N62470-81-B-1478

No. 05-81-1478

AMENDMENT NO. 0001

UTILITIES IMPROVEMENTS  
 at the  
 MARINE CORPS BASE - COURTHOUSE BAY AREA  
 CAMP LEJEUNE, NORTH CAROLINA

CONTROL BUILDING - FLOOR PLAN

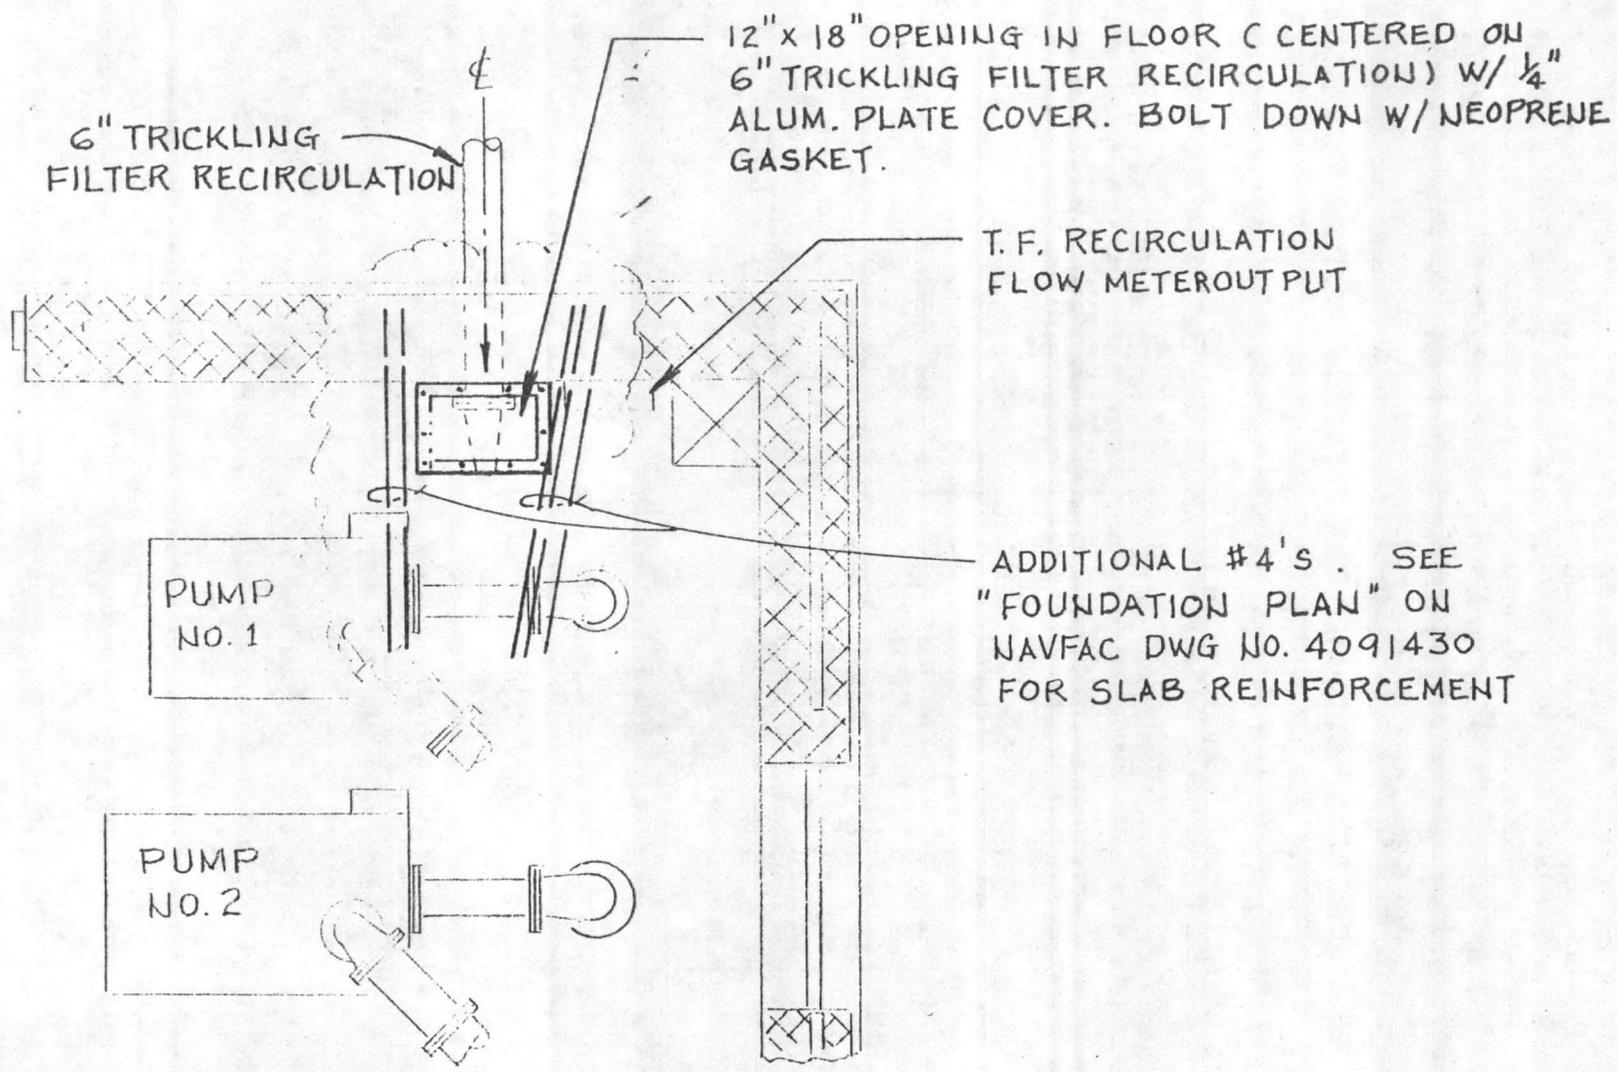
Control Building - Floor Plan: On the exterior wall of the chlorine contact room, revise "flow recorders" to read "1 - effluent meter flow indicator/recorder".

To the list of drawings add LANTDIV Sketch No. SK-C-18-84 which accompanies this amendment.
